Consideration of a request for Preliminary Plat approval for the Grindstone Subdivision consisting of 49 lots located at approximately 500 North Highway 89 in the RA-2 and RA-1, TDR-R Overlay zones.

GRINDSTONE ESTATES
ATLAS A SINGLE FAMILY DEVELOPMENT

Development Review Committee Minutes

February 4, 2022

SHEET NO.
2

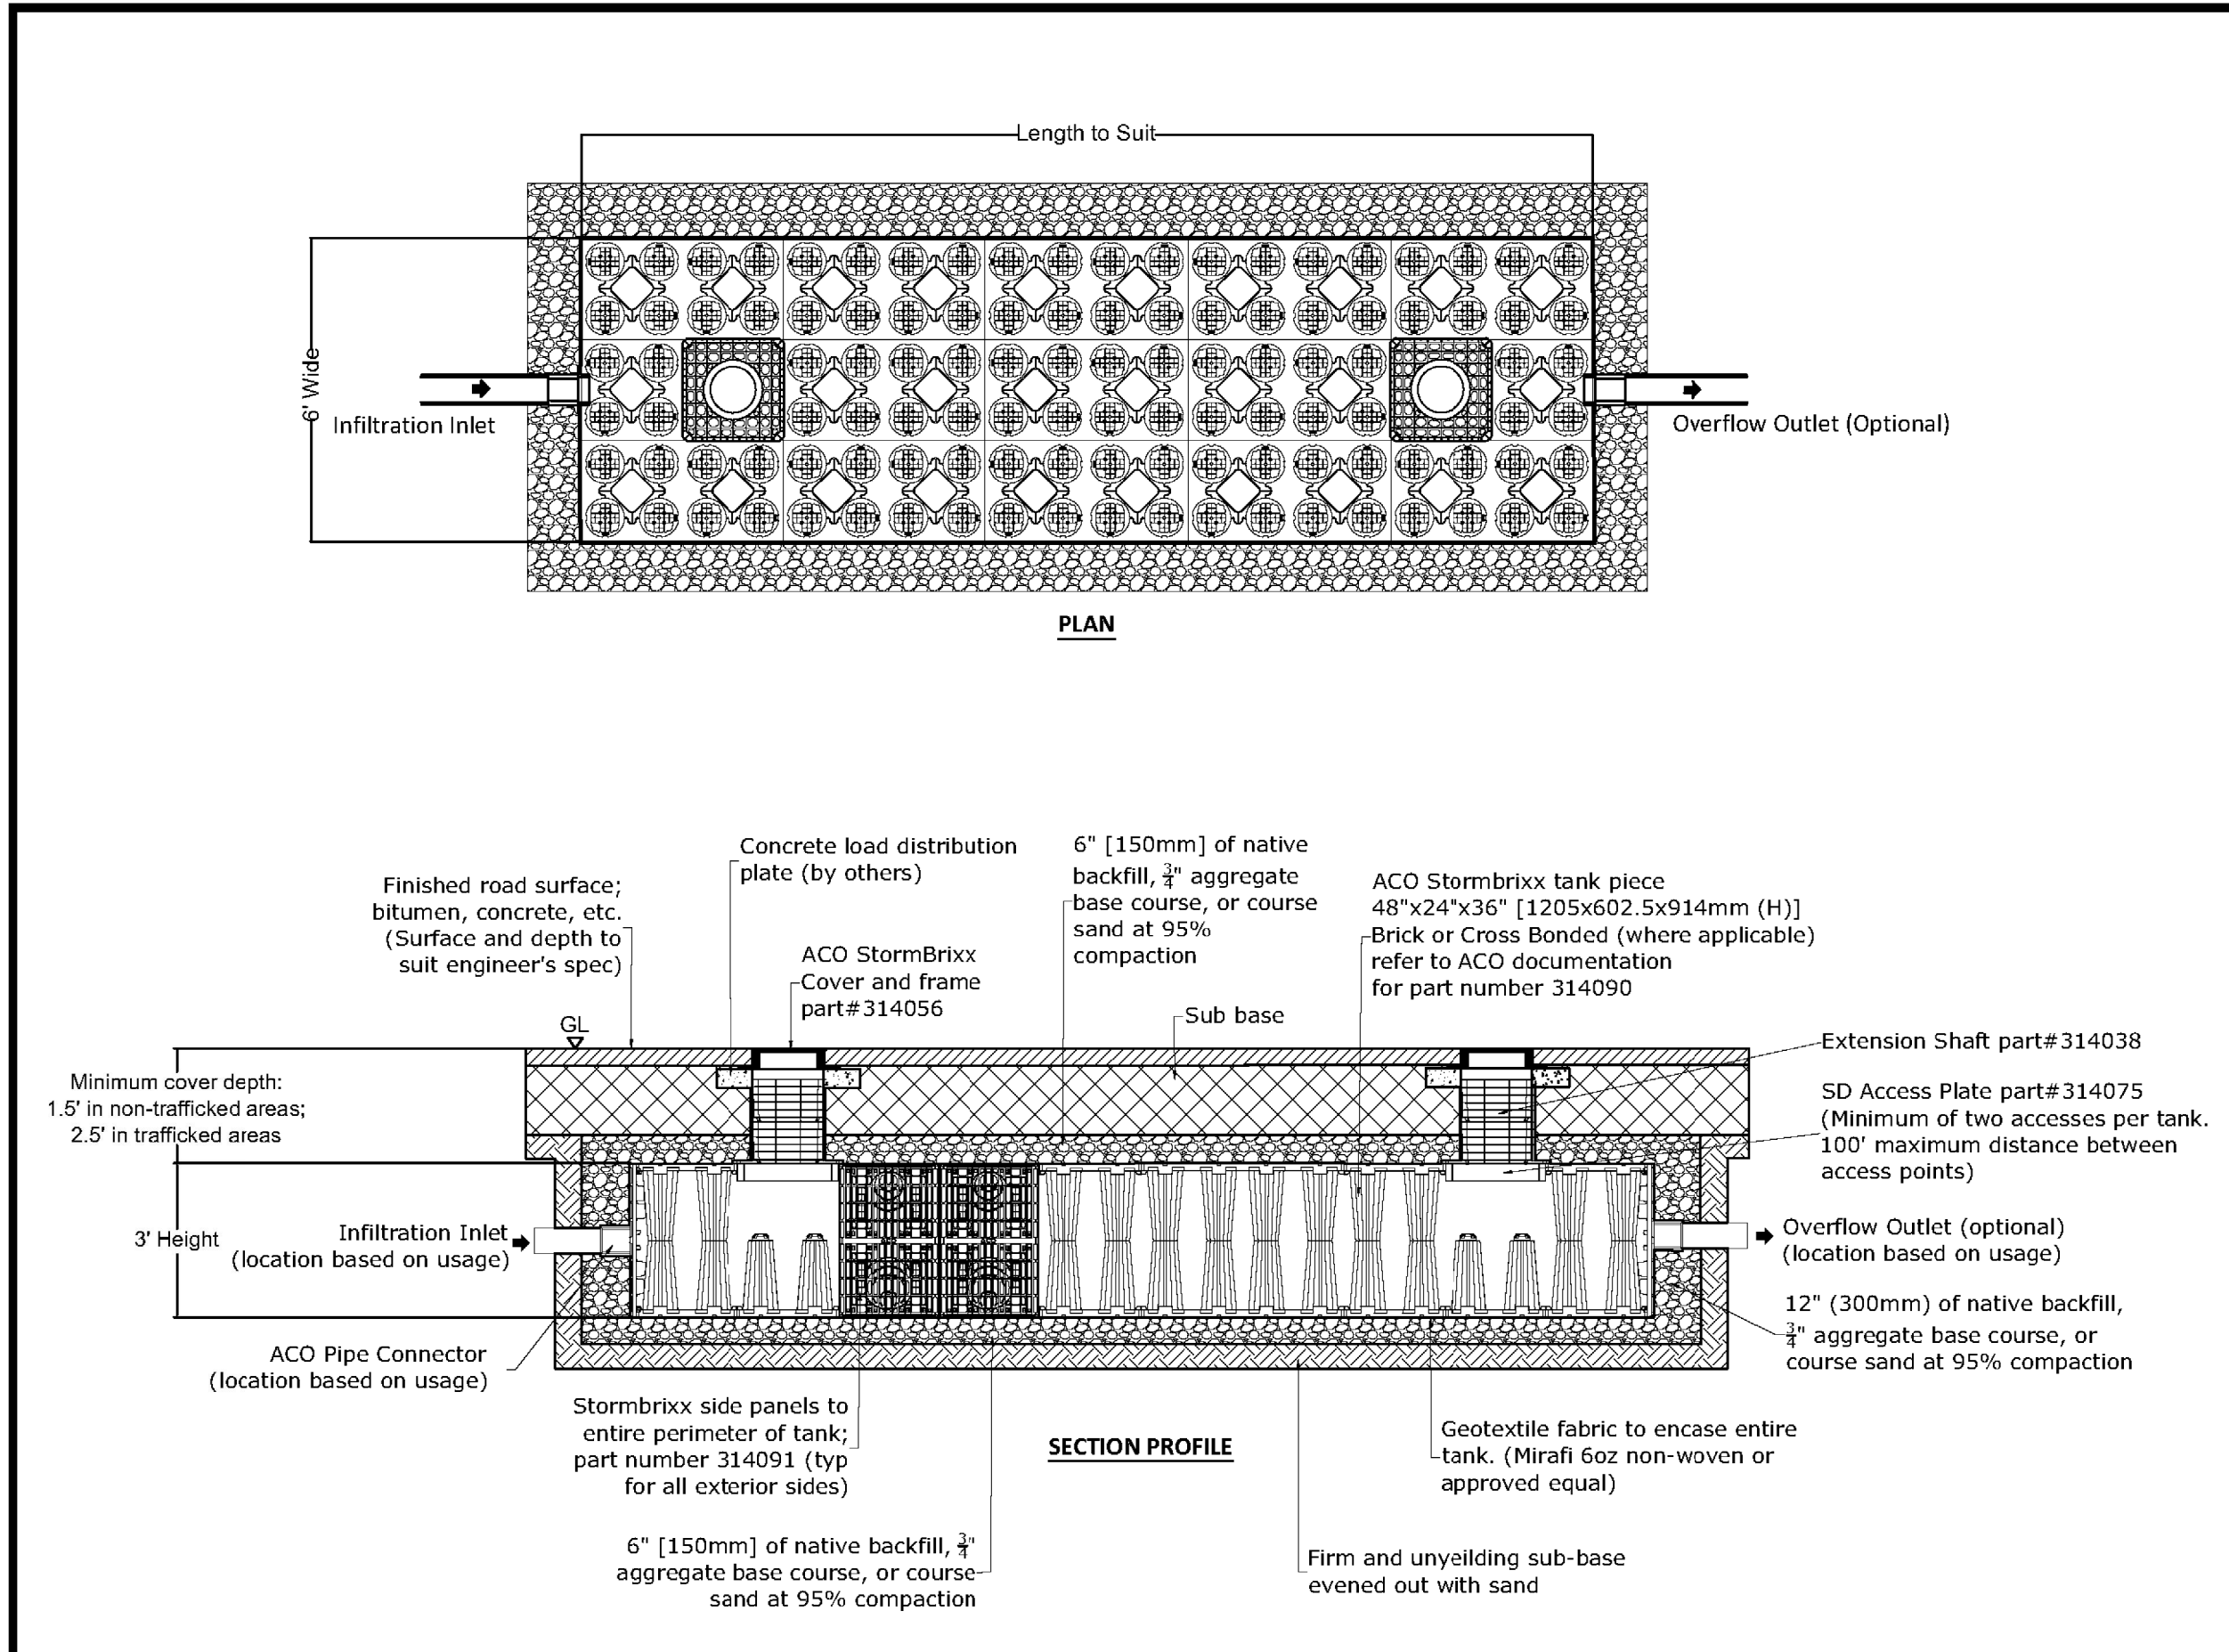
1. Widen entrance on HWY 89 to accommodate future signal following the TIS guidance. Curb returns must line up with Sunrise Ranch Drive, please show this on the plans.
2. Add street centerline geometry labeling
3. Move STOP and STREET sign @ intersection of 400 N and 1100 W to southeast corner
4. Please add crosswalk striping to 400 North intersections
5. Add vertical curve to STREET 2. Max geometric change in slope is 1%
6. STOP signs only at the intersections with 400 North. All other intersections should be YIELD signs.

1. Intersections with 400 North should have streetlights on 2 corners
2. Please submit power plans as soon as possible so the city can design the required fiber network

1. PI Main crossing of HWY 89 must be 12"
2. Include services for HWY 89 landscaping
3. Lots 1-2 are missing PI services

1. Add valve to west side of connection in HWY 89
2. Crossing of HWY 89 must be 12"
3. Upsize HWY 89 culinary main to 8" per city master plan
4. Ensure 10' separation between water services and sewer services, multiple locations

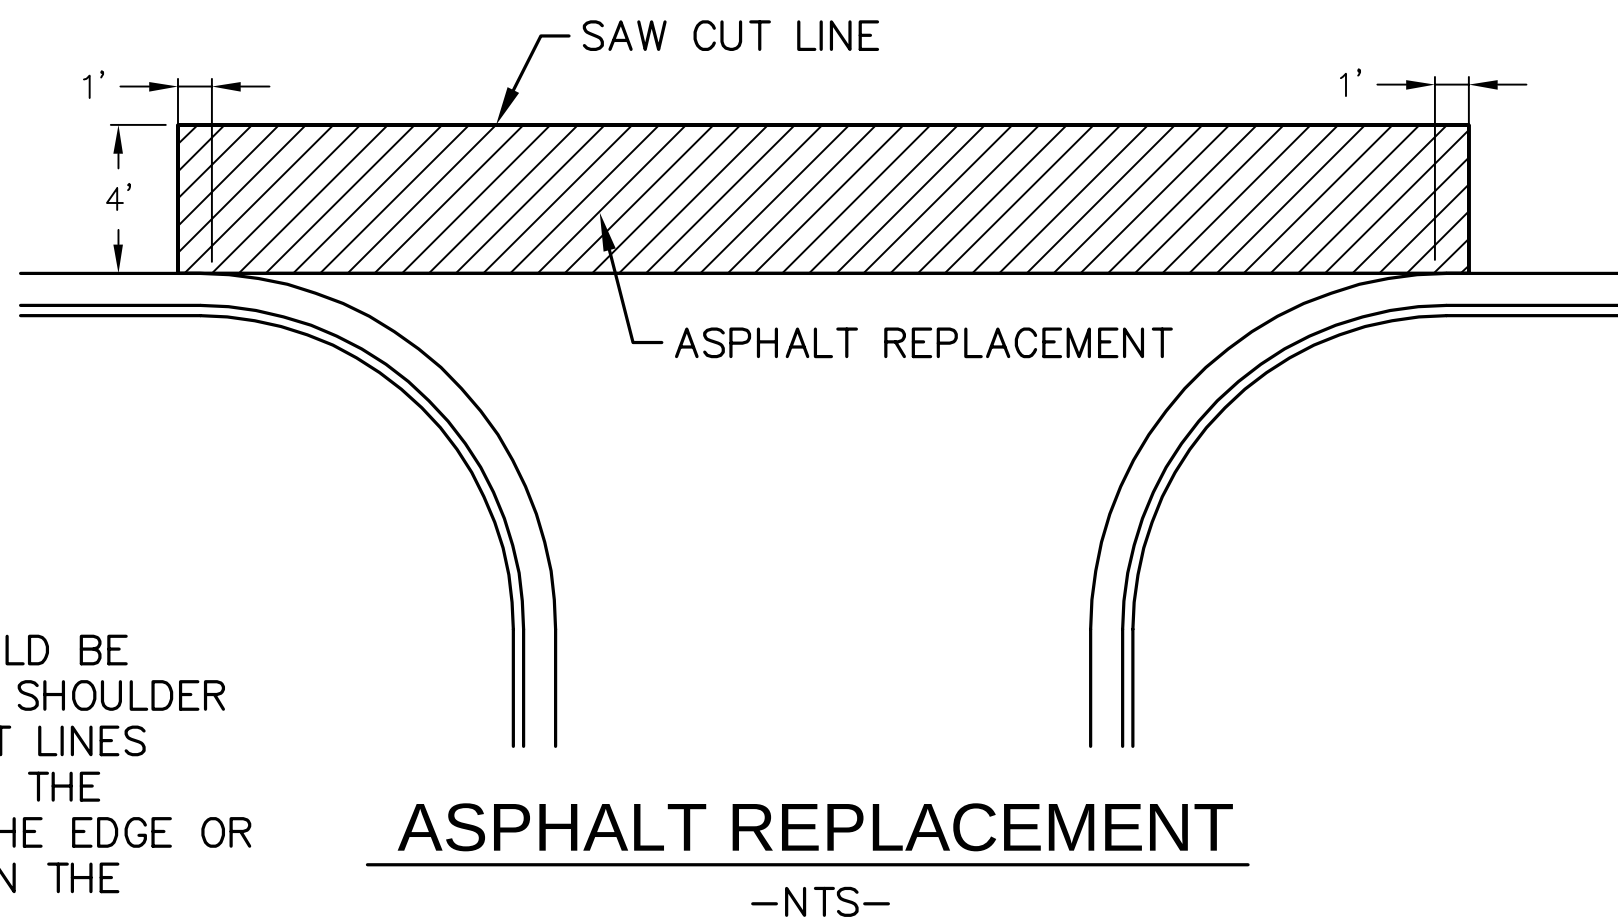
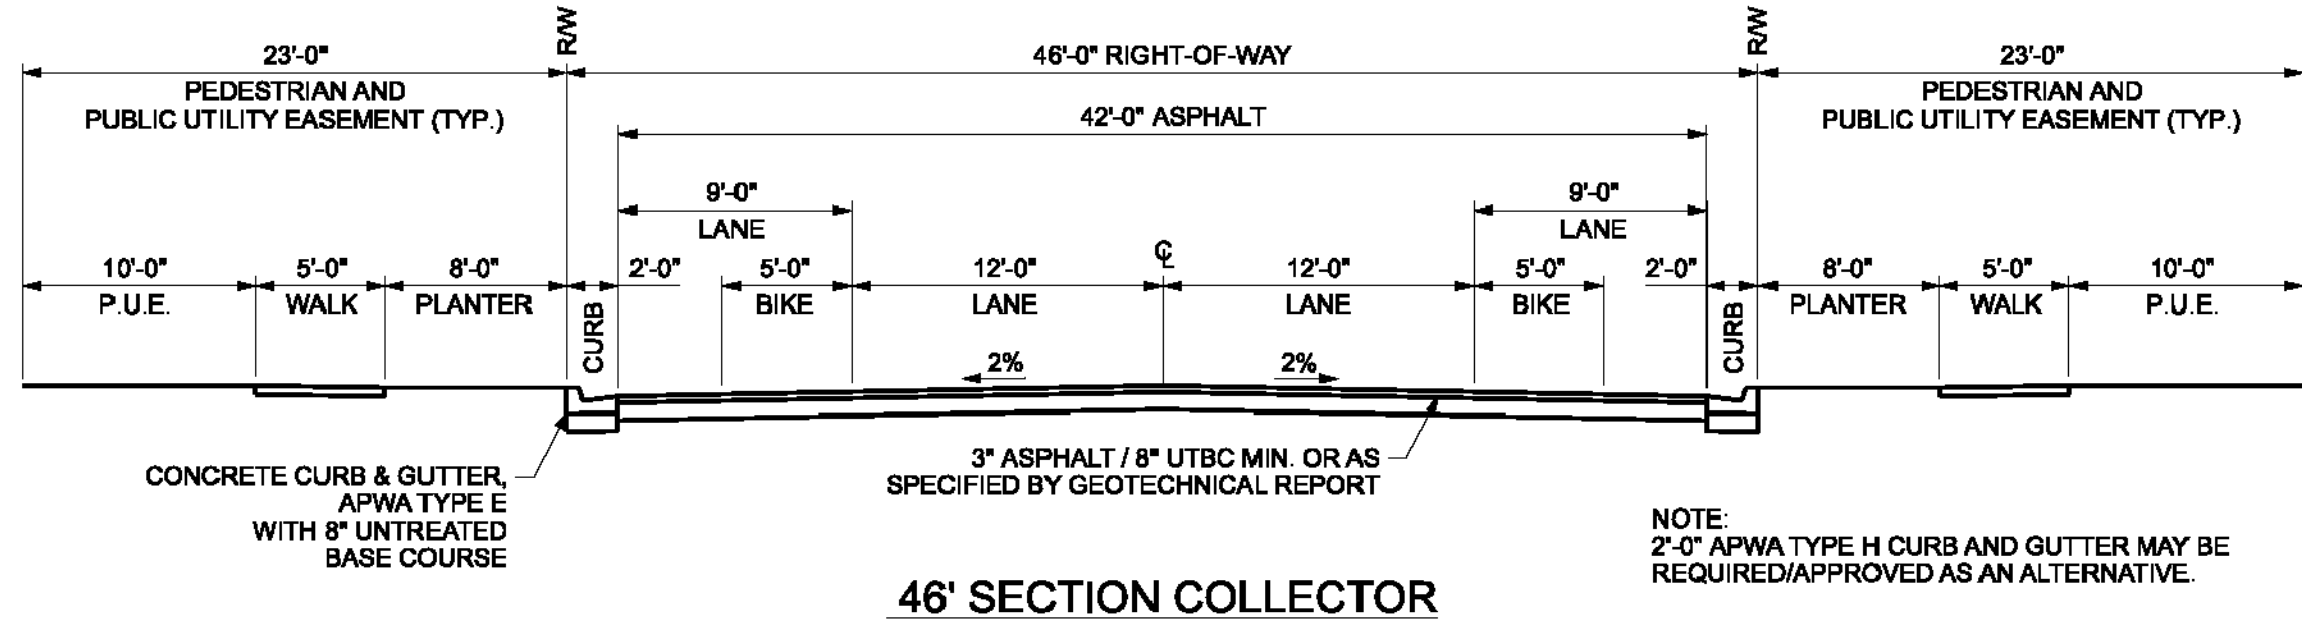
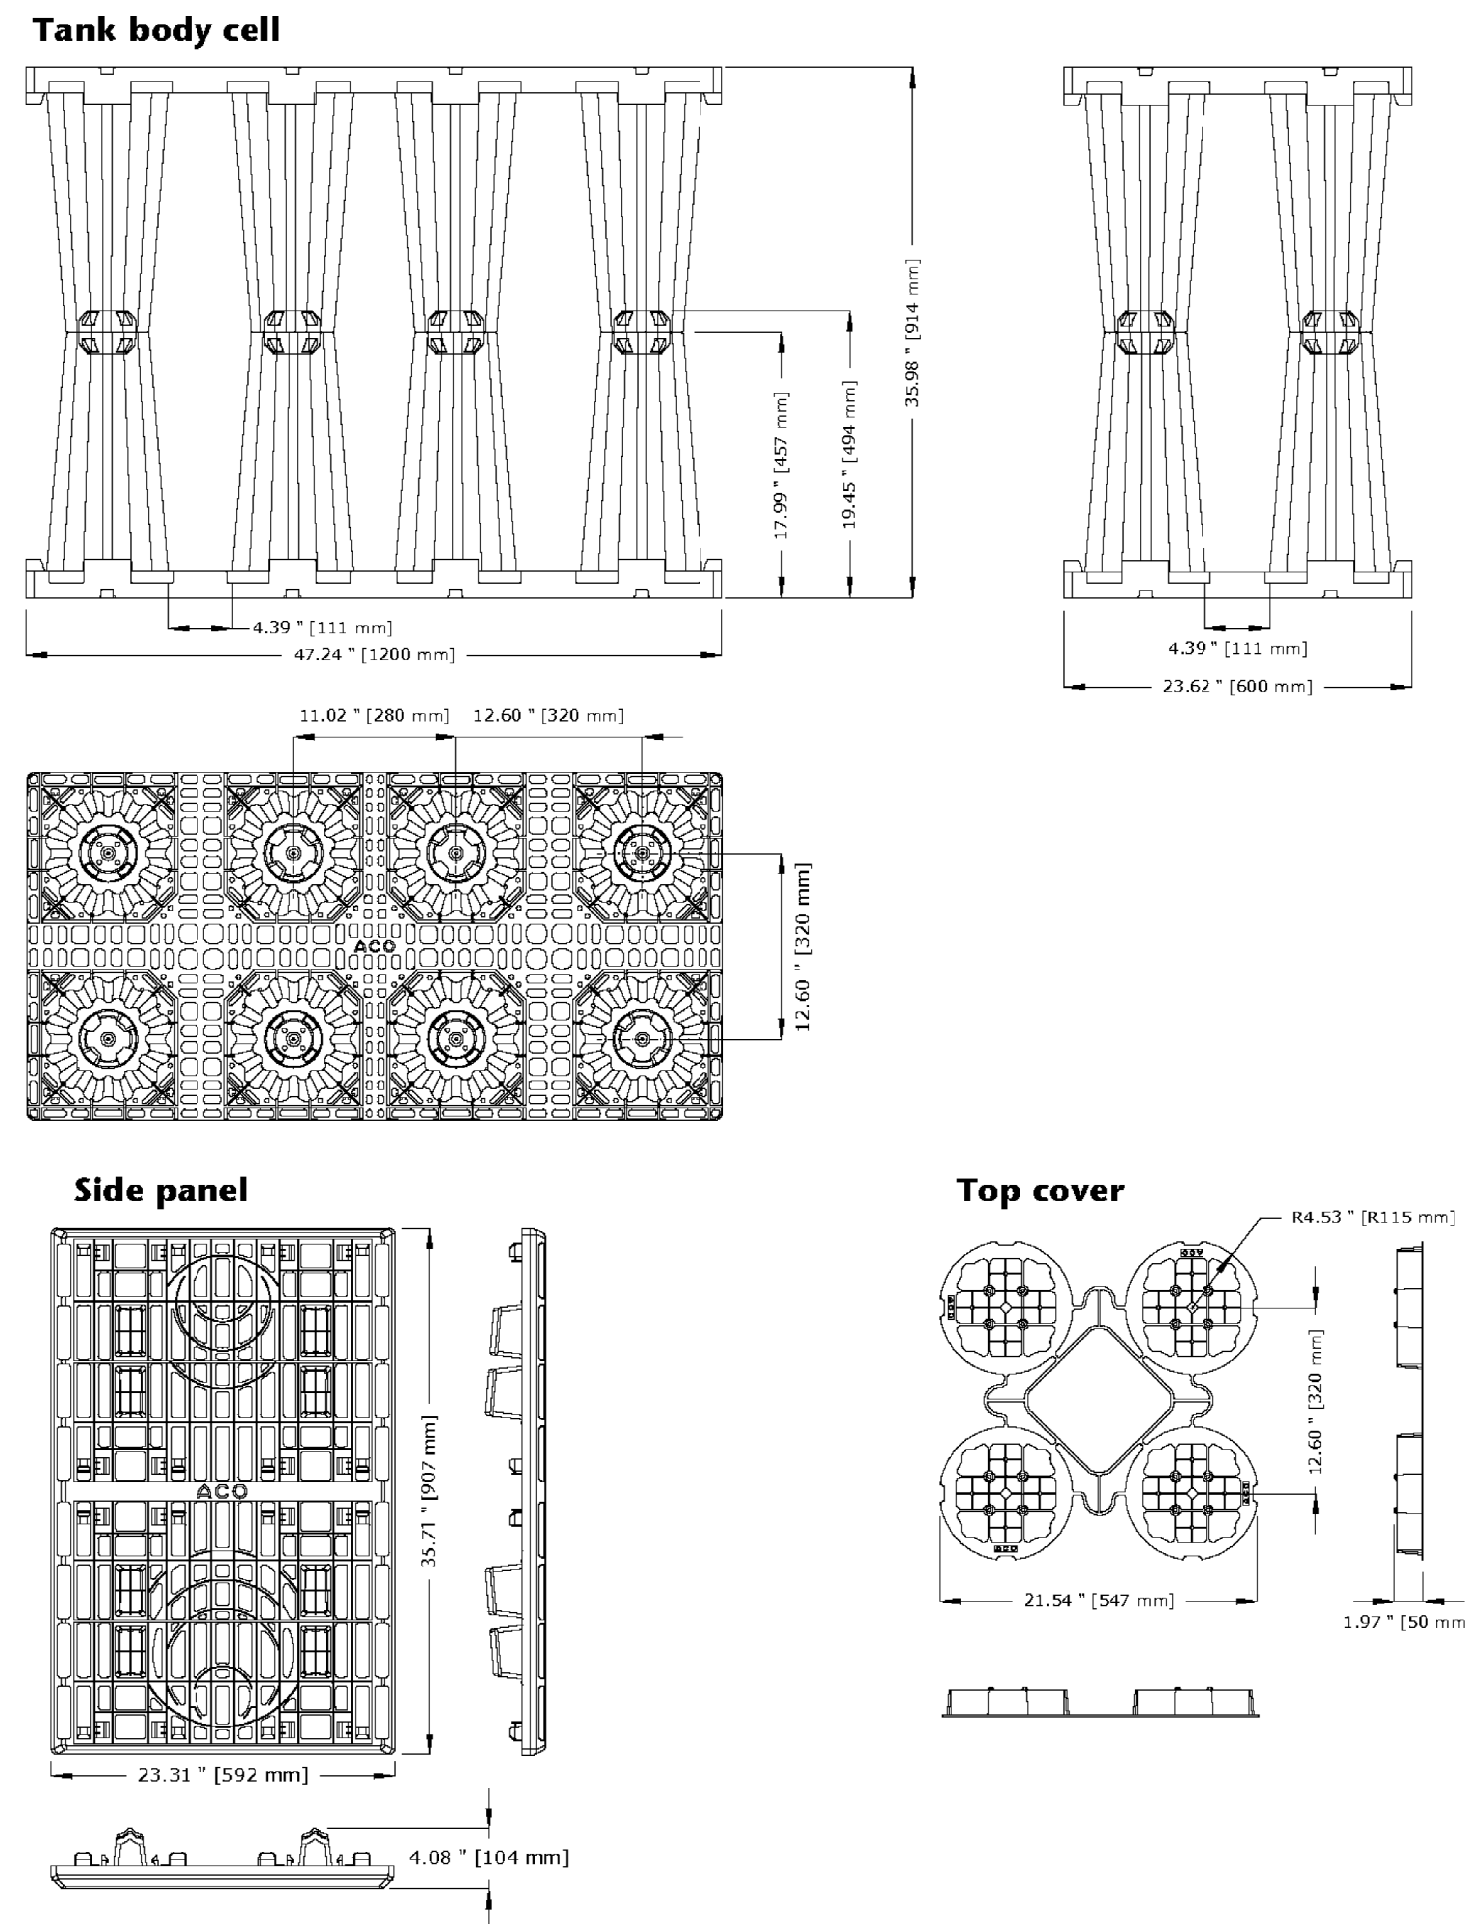
1. Inlets immediately prior to storage chambers must be pre-treatment inlets with snout and oil absorbent pillows – where is the note?
2. More information is needed for the STORMBRIX chambers, inlet elevations, cleanout access locations, pipe size and material etc.
3. Missing elevation information on SD manhole in HWY 89 Sheet PP-15
4. Minimum storm drain RCP pipe slope is 0.4%, please correct everywhere
5. Max inlet spacing 300'
